CONSTRUCTION PLANS FOR HIGHPOINT OAKS ESTATES

CITY OF LEWISVILLE DENTON COUNTY, TEXAS

PRELIMINARY FOR REVIEW ONLY
 NOT FOR CONSTRUCTION OR PERMIT PURPOSES

INDEX

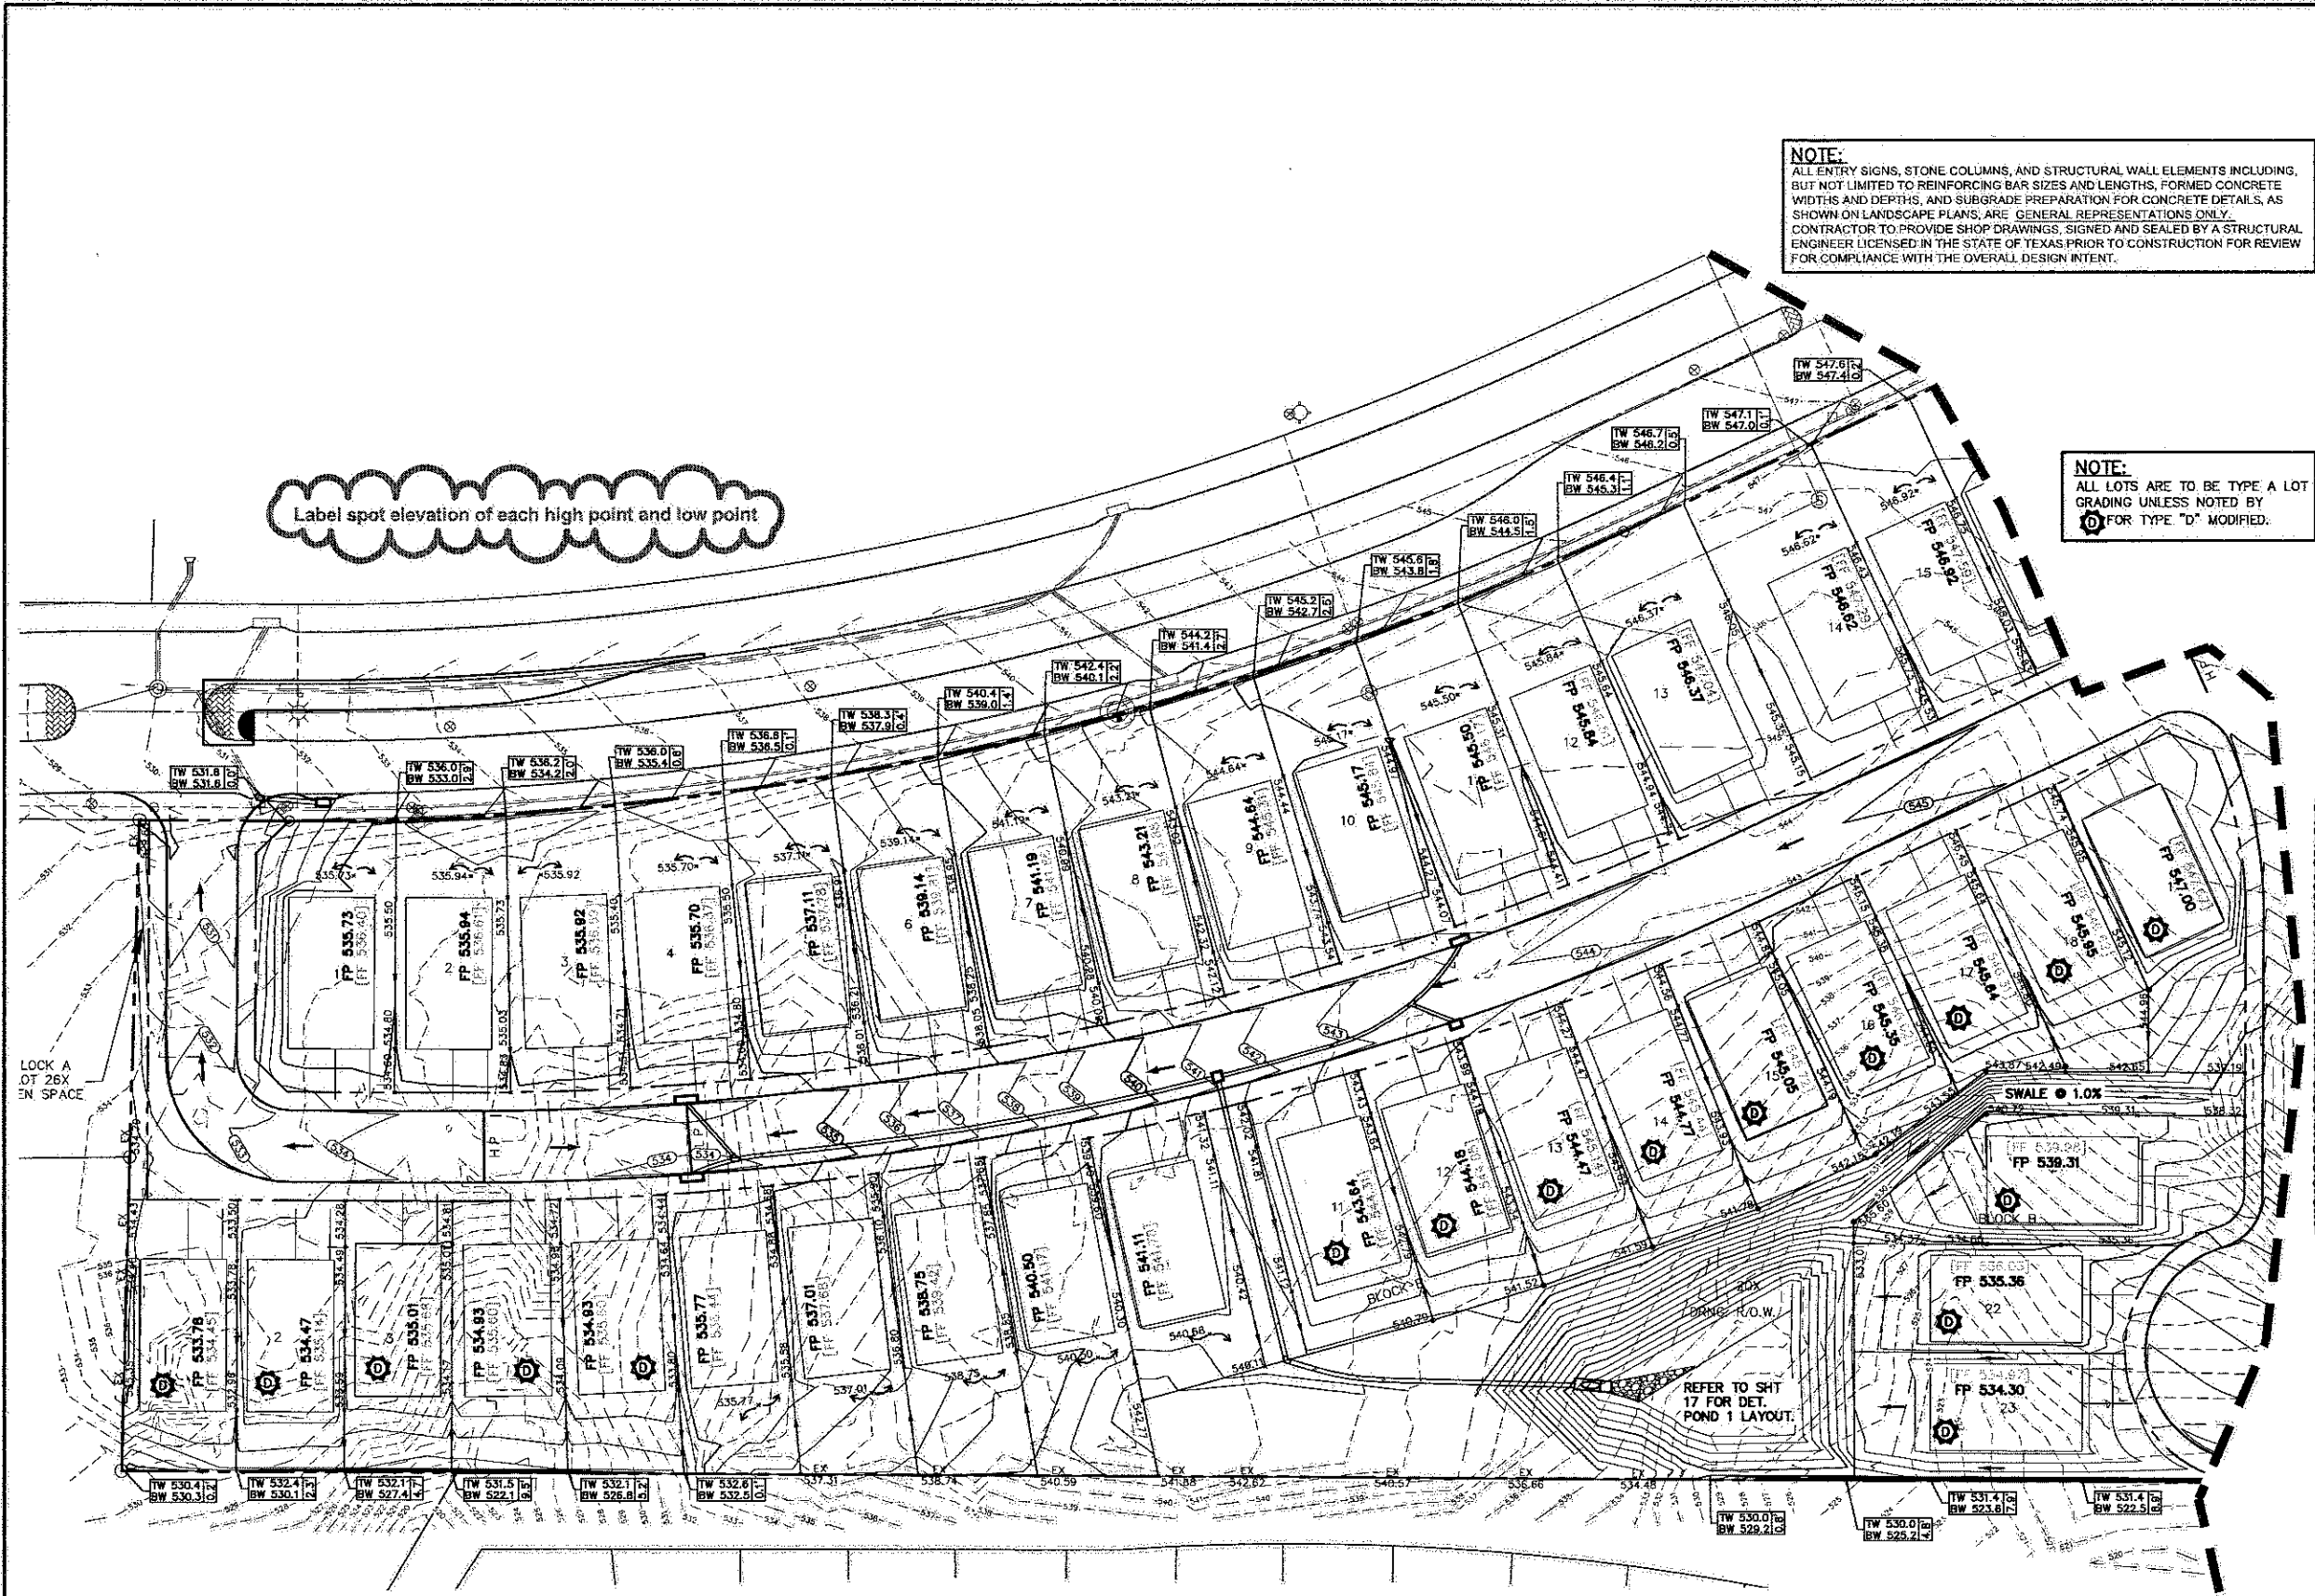
Add not to cover sheet that developer shall pay a screening wall maintenance fee of 20% of the cost of the public screening wall.

Add all applicable City of Lewisville details to the plan set.

Add retaining wall plans.

GRADING PLAN SHEET 2
HIGHPOINT OAKS ESTATES
City of Lewisville, Denton County, Texas

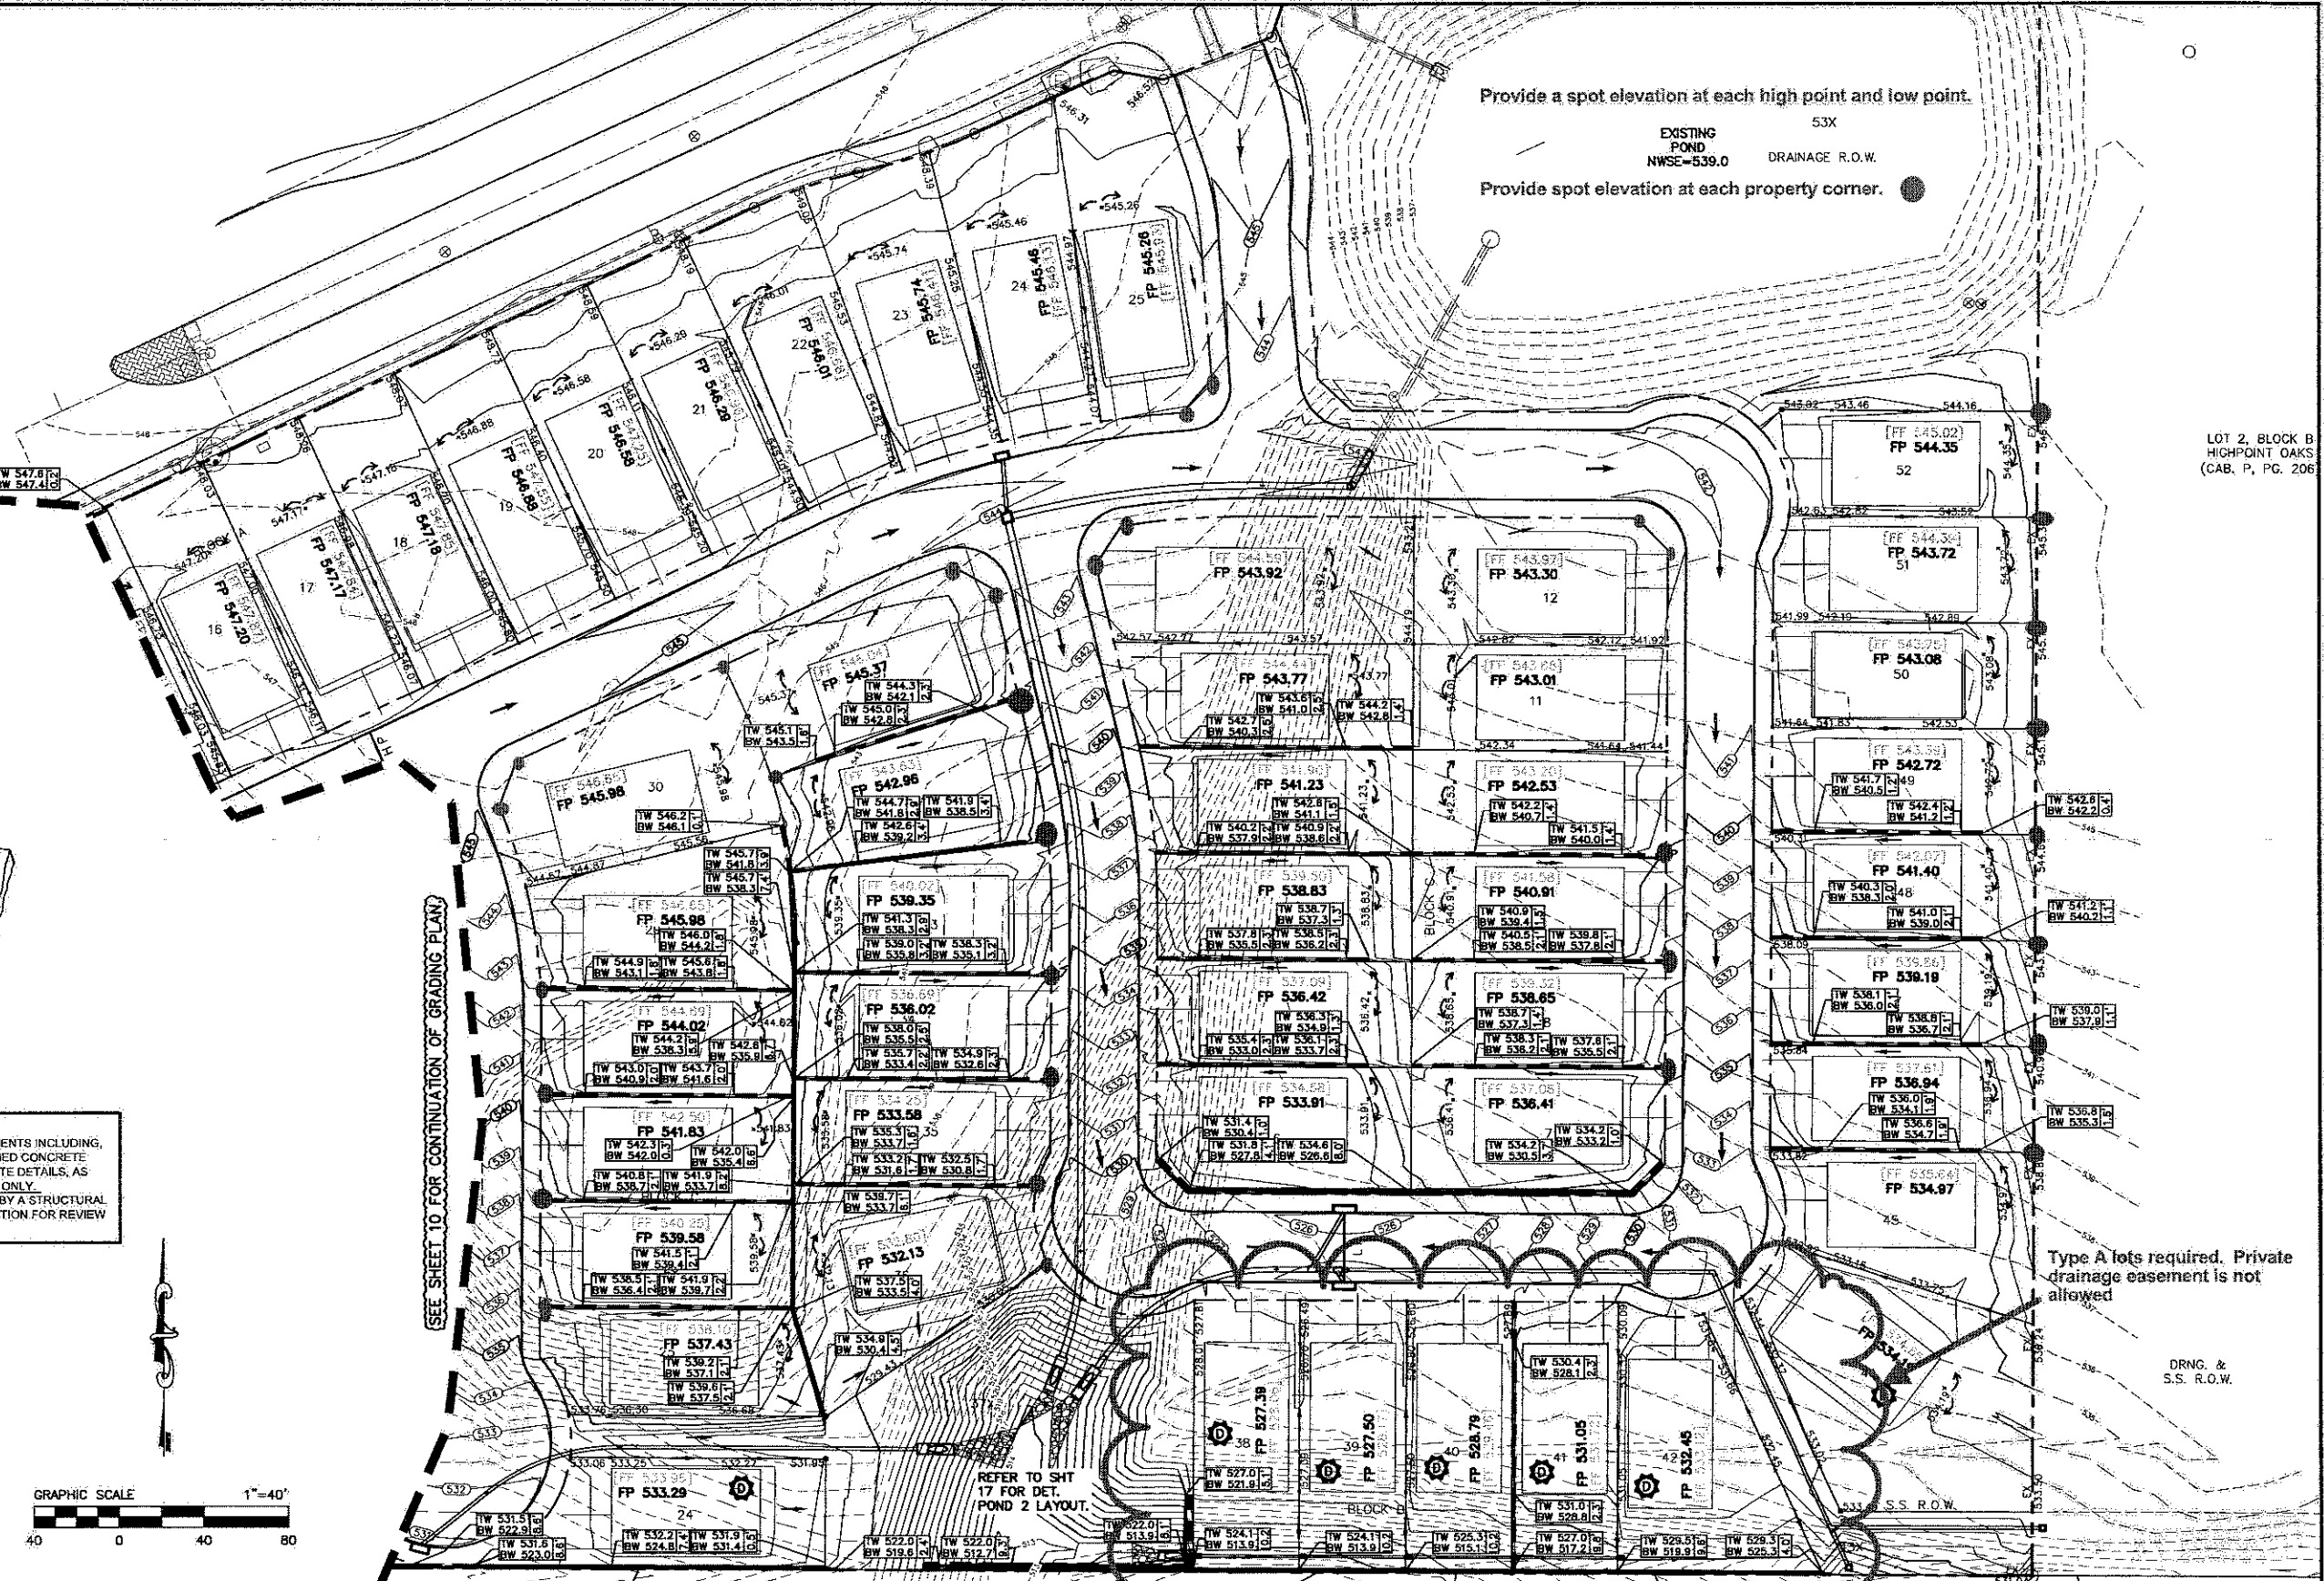
Provide a spot elevation at each high point and low point.

Provide spot elevation at each property corner.

DETENTION POND 1		PROJECT NO.
DETAILS & CALCULATIONS		GEH004
HIGHPOINT OAKS ESTATES		SHEET NO.
City of Lewisville, Denton County, Texas		17

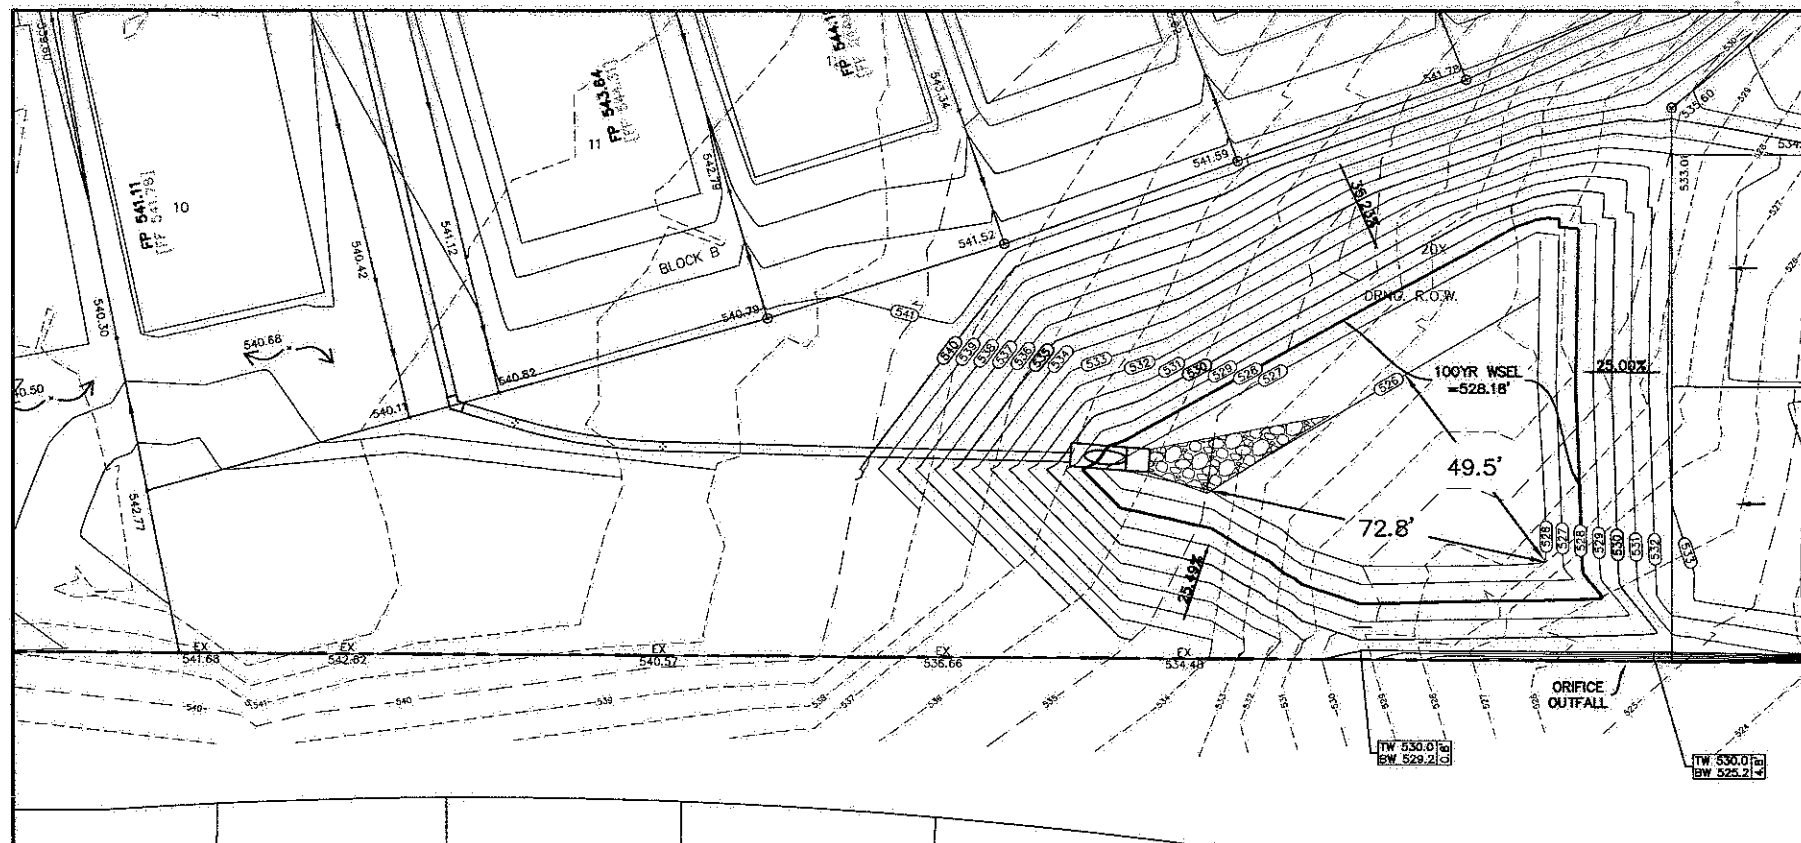
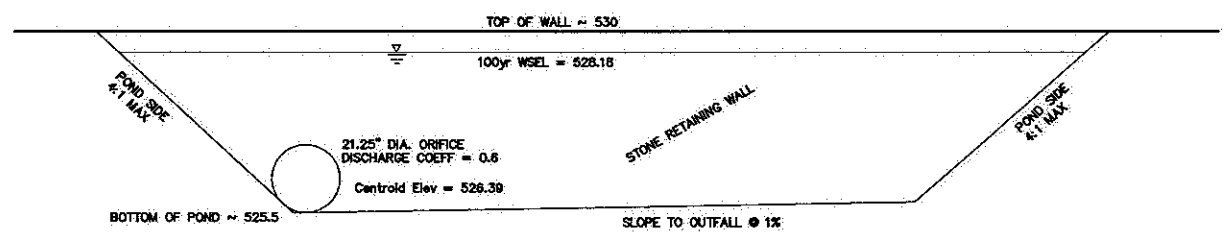
Show outlet pipe and headwalls

DETENTION POND 2		PROJECT NO.
DETAILS & CALCULATIONS		GEH004
HIGHPOINT OAKS ESTATES		SHEET NO.
City of Lewisville, Denton County, Texas		18

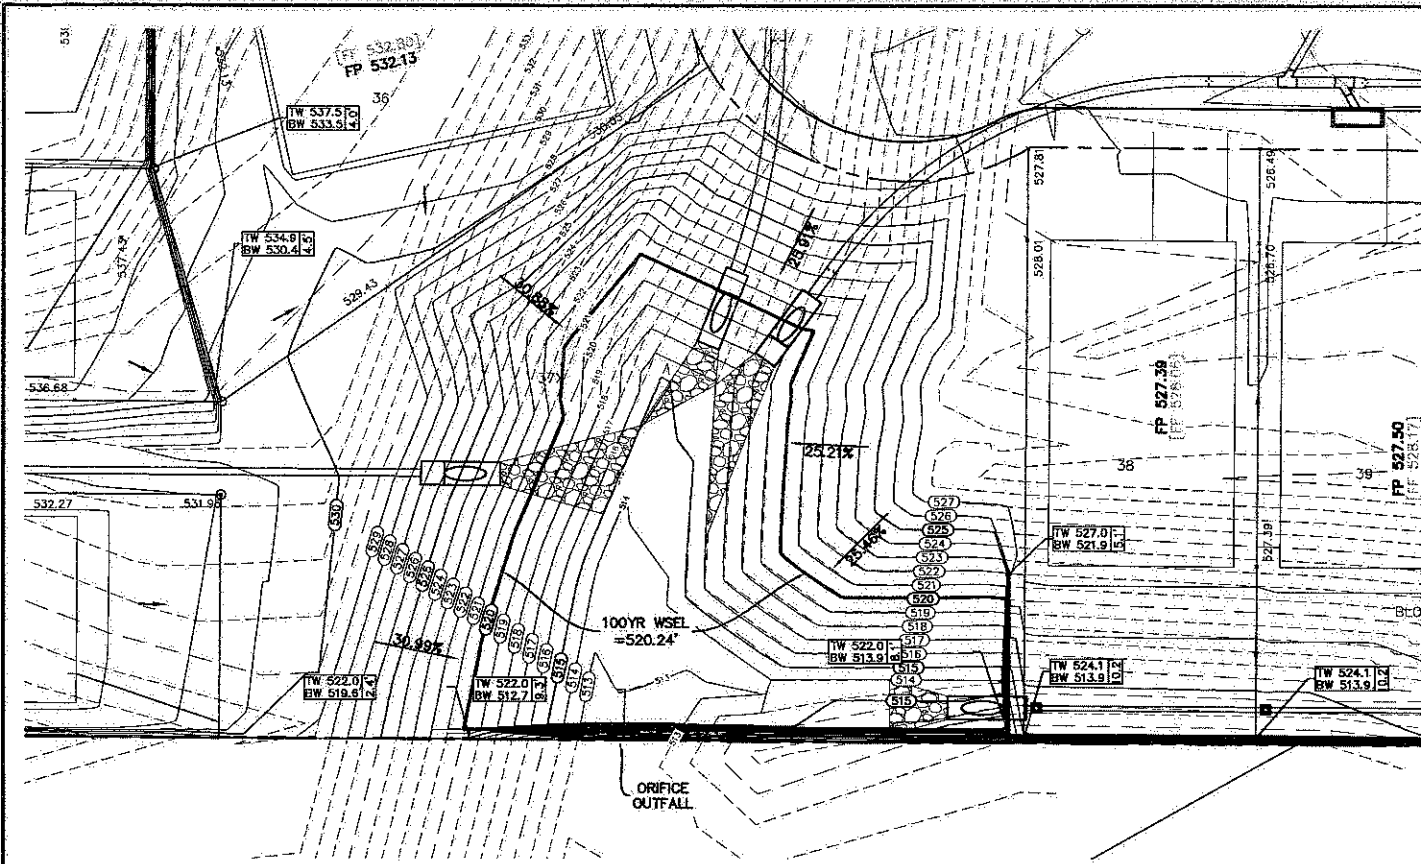
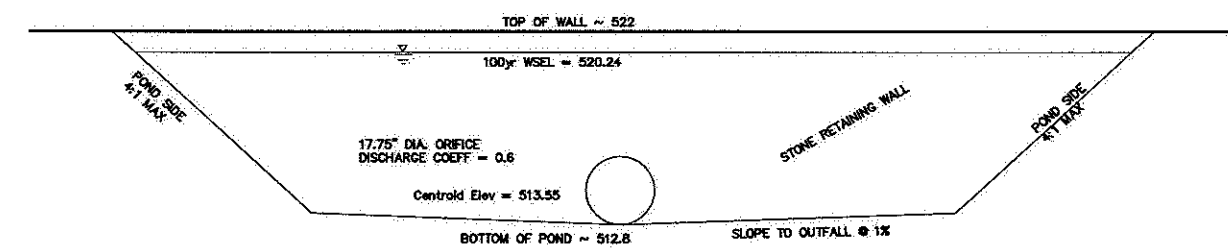
Show outlet pipe and headwalls on plan.
